TO: CULTURAL HERITAGE BOARD

MEETING DATE: APRIL 18, 2018

**SUBJECT: P18-0186 CERTIFICATE OF APPROPRIATENESS – BY CITY OF RIVERSIDE
BUILDING SERVICES DEPARTMENT TO CONSTRUCT AN APPROXIMATELY
42,000 SQUARE-FOOT NEW MAIN LIBRARY AND DEMOLISH EXISTING
STRUCTURES AT 3911 UNIVERSITY AVENUE/3775 FAIRMOUNT BLVD**

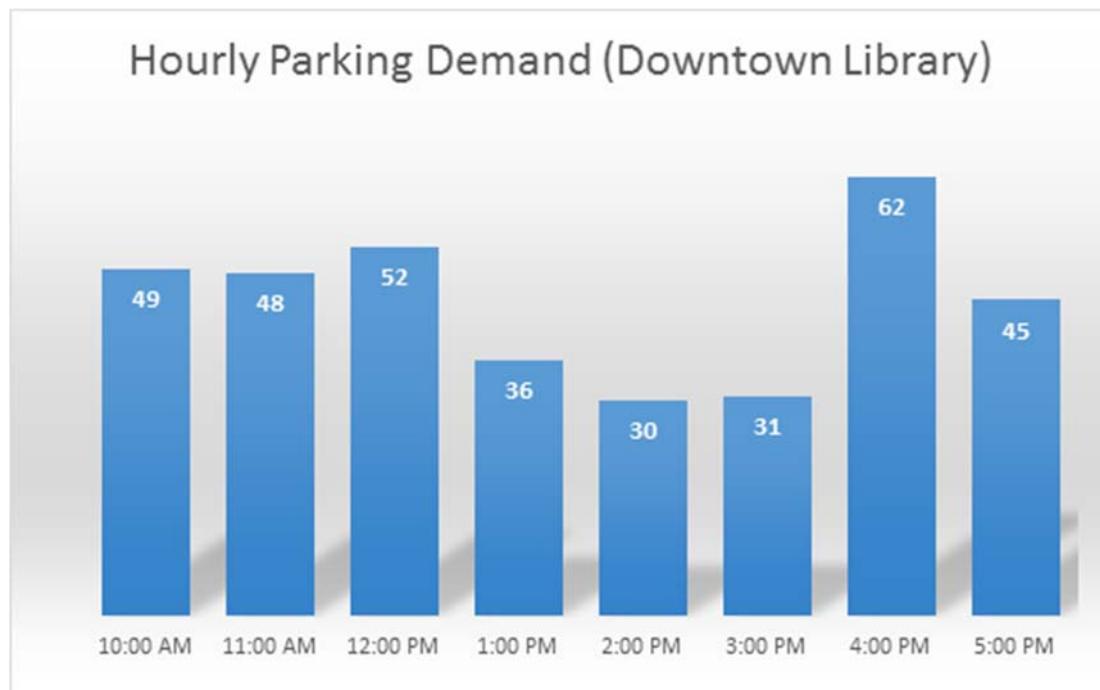
2. Sufficiency of Proposed Parking

The chart below displays peak hourly parking demand for the existing Downtown Library using hourly parking distributions found in the Institute of Transportation Engineers (ITE) Parking Generation Manual (4th Edition). The peak hourly parking demand was estimated by scaling the ITE average peak demand for a library of 42,400 SF against traffic counts conducted during the peak hour of traffic at the existing Downtown Library parking lot. It should be noted that the estimated peak demand of 62 vehicles is conservative, because not all motorists entering the library lot during the peak hour use the parking lot for library purposes, and not all library patrons who reported driving to the library represent one vehicle. If the walk-in survey data is used to scale the parking demand, a peak hourly parking demand of 48 vehicles can be expected.

Against nationwide studies, the existing library attracts below-average number of patrons per square foot. The new library is anticipated to serve more patrons in a space approximately 18,000 square feet smaller with a larger proposed parking field of 66 spaces. This growth is anticipated to consist largely of walking and bicycling traffic because the library will be constructed in close proximity to over 500 new residential units located within walking distance in the Central Business District and will be connected across Market Street by two new diagonal crosswalks, and two new pedestrian beacon crossings. The library will also feature bicycle amenities. Future development to the rear is anticipated to reconfigure the proposed surface parking lot into a subterranean structure and provide even greater parking with 120 parking stalls granted via easement for exclusive use by the library in perpetuity.
